Memorandum

To: Planning and Public Works Committee
From: Mike Knight, Assistant City Planner *JMK*
Date: May 19, 2022

RE: **Wildhorse Village, Lot 2B-1 (Wildhorse Village Condos) SDSP:** A Site Development Section Plan, Landscape Plan, Lighting Plan, Architectural Elevations and Architect's Statement of Design for a 0.8 acre tract of land zoned "PC&R" – Planned Commercial and Residence District located southeast of the intersection of Parkview Terrace and Wildhorse Lake Blvd. (Ward 4)

Planning Commission Staff Report

1 ROOF PLAN - ARB
A.004 1/8" = 1'-0"

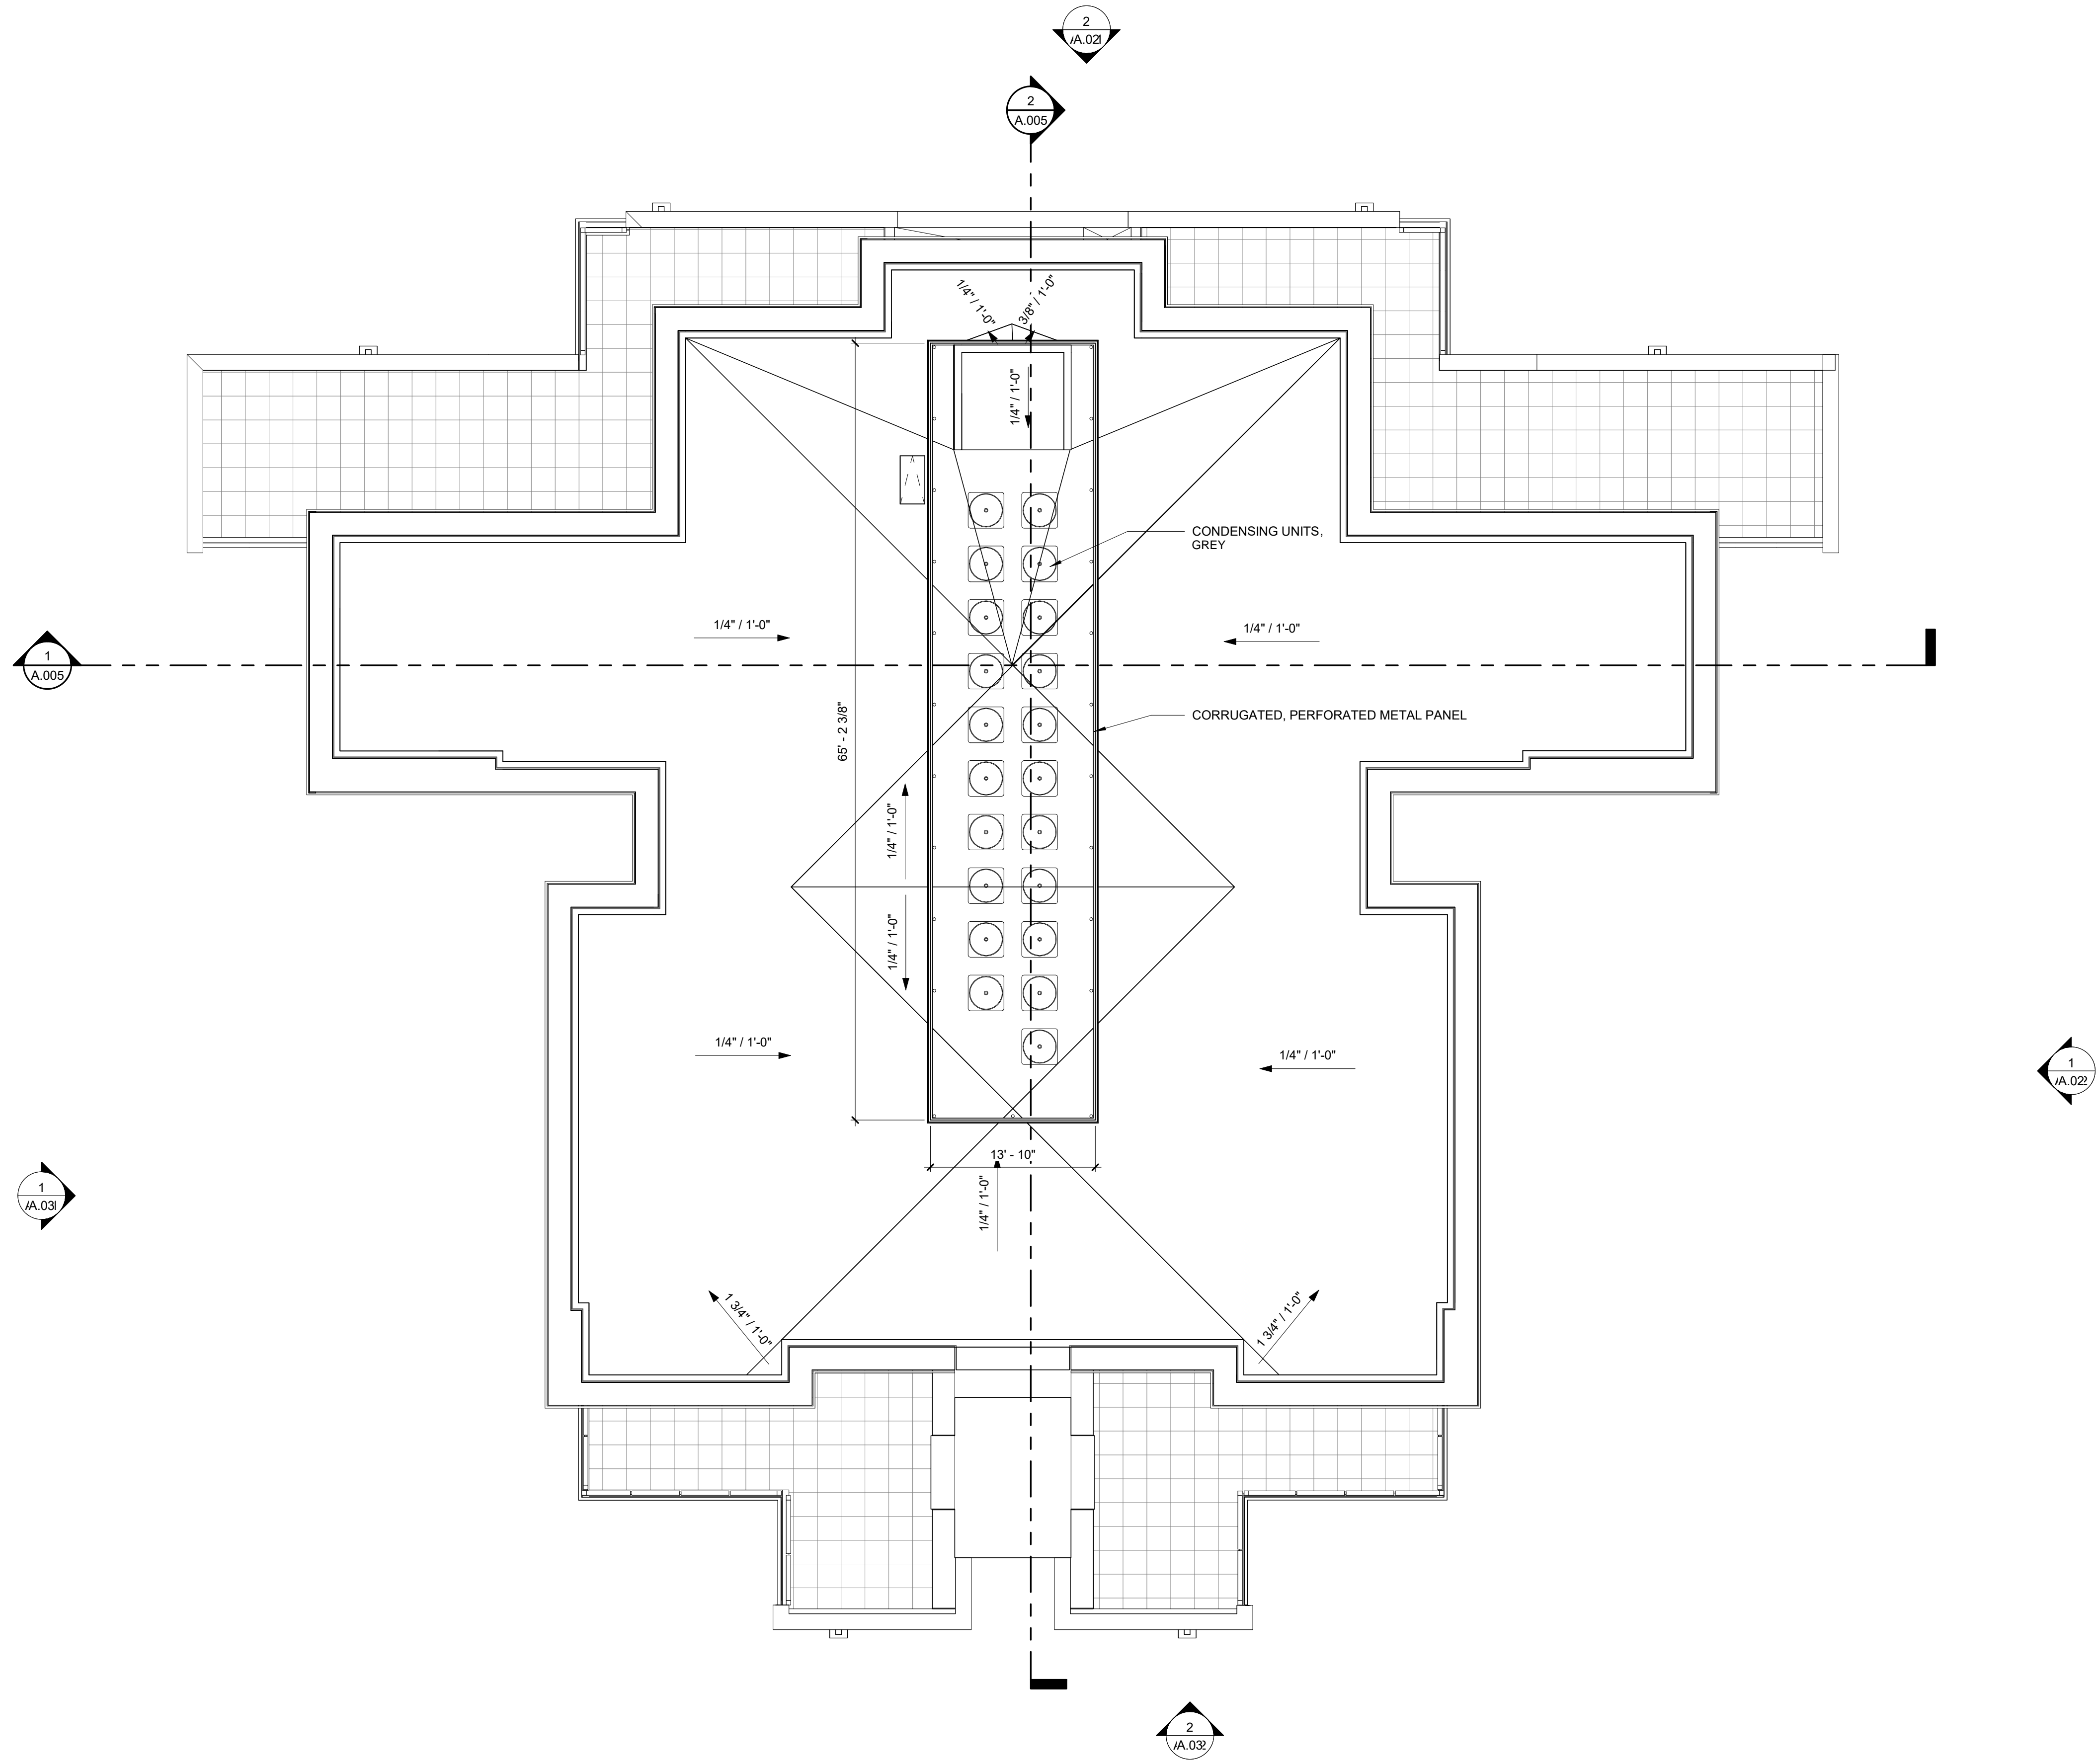
A modification is being requested in regards to the rooftop mechanical screening requirement. Ordinance 3161 states, "rooftop mechanical equipment shall be permitted on roof within architecturally designed, fully enclosed penthouses that complement the building design". The applicant is proposing to screen the rooftop equipment on all visible sides with materials that are an integral part of the

A modification is being requested in regards to the rooftop mechanical screening requirement. Ordinance 3161 states, "rooftop mechanical equipment shall be permitted on roof within architecturally designed, fully enclosed penthouses that complement the building design". The applicant is proposing to screen the rooftop equipment on all visible sides with materials that are an integral part of the architecture. A full narrative of the modification request is included in this packet.

- Provide a color for the rooftop units that is color compatible with the surrounding architectural elements
- Revise the landscape placement and species around the base of the building to be less formal and rigid to promote a more natural design.

The applicant has since resubmitted and fulfilled both conditions. All of the updates have been included with the Planning Commission packets. The Board was supportive of the aforementioned modification request.

We request a modification to Section IG.5 of Ordinance No. 3161, which states: "rooftop mechanical equipment shall be permitted on roofs within architecturally designed, fully enclosed penthouses that complement the building design." We are proposing to enclose the elevator overrun and rooftop equipment with a cohesive material with consistent top trim that is an integral part of the architecture and will not visually weaken the design of the structure, per UDC Section 405.04.010. The top of the enclosure will remain open for free ventilation.

Therefore, we are showing all units together over the central corridor. A screen wall will encompass the equipment as well as the elevator overrun to provide a singular, seamless surround that invokes the continuation of the corridor spine up through the roof. In order to accomplish this, we are proposing a metal panel screen of the same warm grey color and horizontal aesthetic as the other trim on the building at the roof level. We feel this solution provides the best aesthetic of simply another stepped back building level continuing with the theme below.
